On August 1, 2012 new emergency chapter 11B code provisions became effective. Attached are copies of the emergency express terms and the applicable figures. The new requirements are underlined and deleted items are struck-out. These changes should be enforced accordingly.

**EMERGENCY EXPRESS TERMS  
FOR  
PROPOSED BUILDING STANDARDS  
OF THE  
DIVISION OF THE STATE ARCHITECT**

**REGARDING PROPOSED CHANGES TO  
CALIFORNIA BUILDING CODE  
CALIFORNIA CODE OF REGULATIONS, TITLE 24, PART 2  
ACCESSIBILITY TO PUBLIC BUILDINGS,  
PUBLIC ACCOMMODATIONS, COMMERCIAL BUILDINGS AND  
PUBLICLY FUNDED HOUSING**

FIGURE 11B-1A

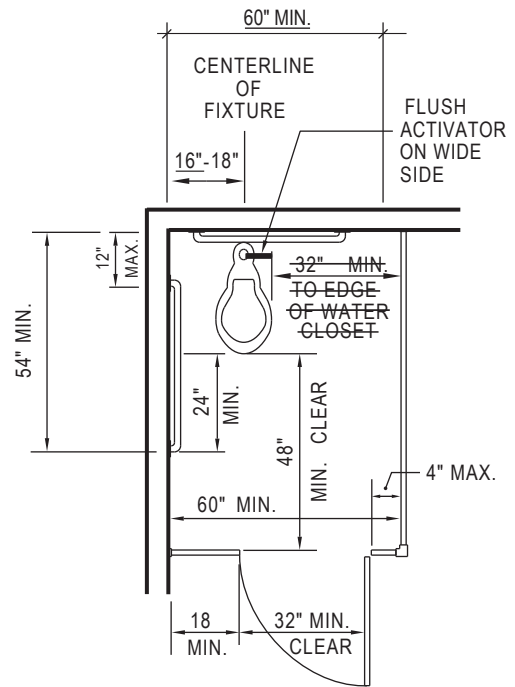
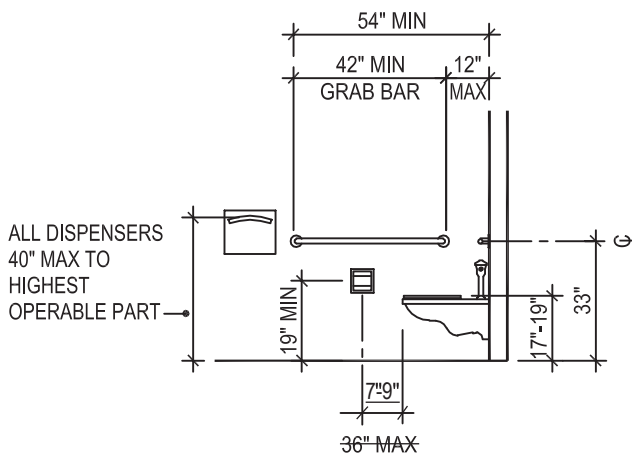
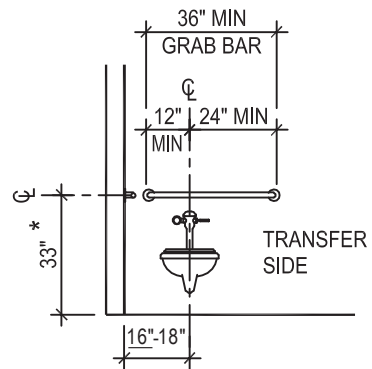
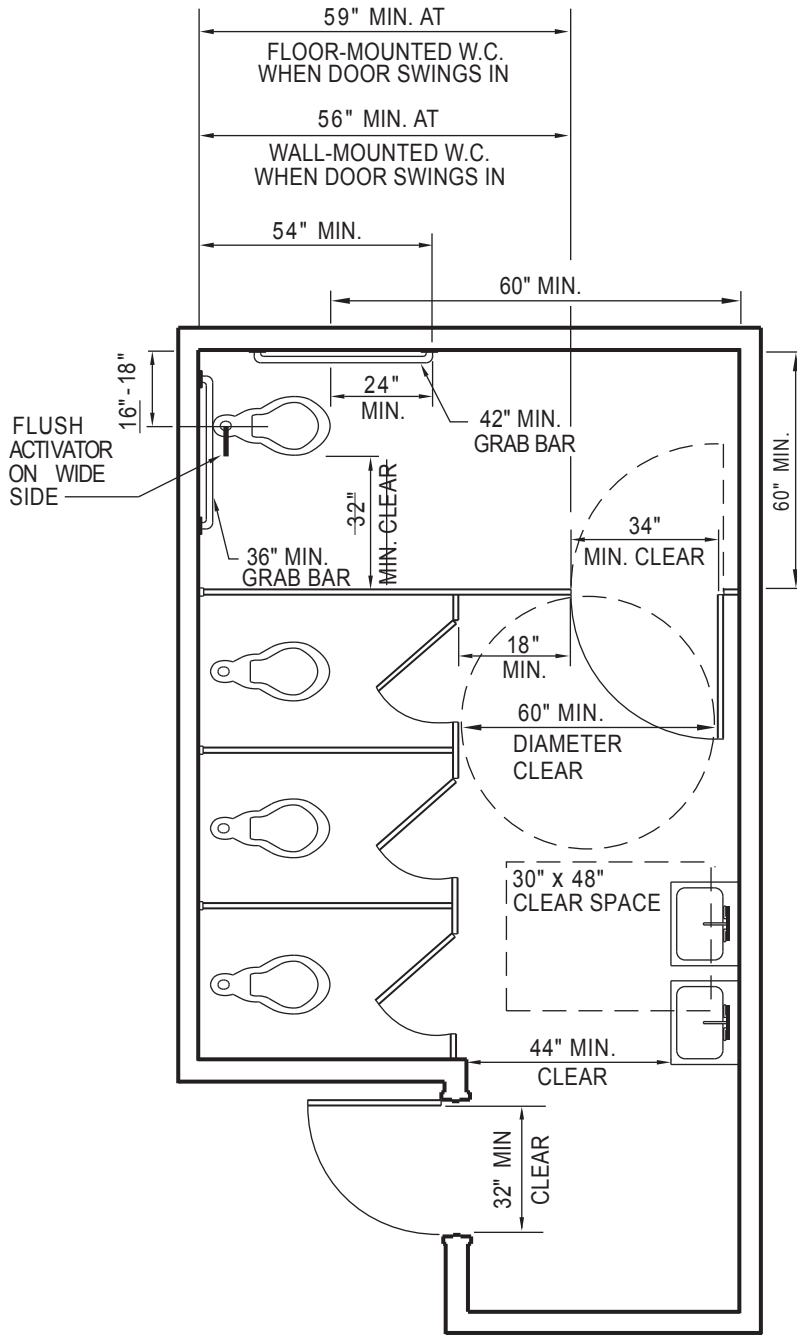
Related code changes are proposed for Figures 11B-1A and 11B-1B for consistency.

**1115B.8.4 Toilet tissue dispensers.** *Toilet tissue dispensers shall be located on the wall within 12 inches (305 mm) of the front edge of the toilet seat, wall or partition closest to the water closet, 7 inches (180 mm) minimum and 9 inches (230 mm) maximum in front of the water closet measured to the centerline of the dispenser, mounted below the grab bar, with the outlet of the dispenser at a minimum height of 19 inches (485 mm), and 36 inches (914 mm) maximum to the far edge from the rear wall. Dispensers that control delivery or that do not permit continuous paper flow shall not be used. See Figure 11B-1A.*

FIGURE 11B-3A - DRINKING FOUNTAINS

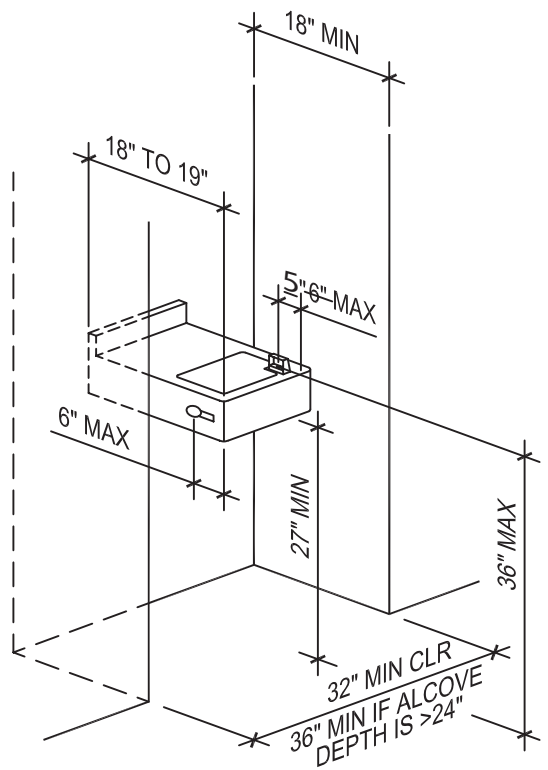
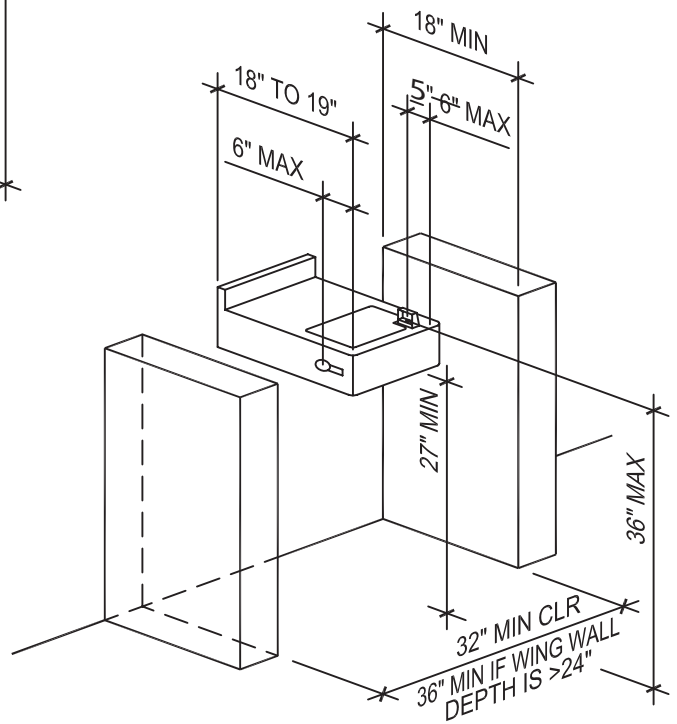
A related code change is proposed for Figure 11B-3A for consistency.
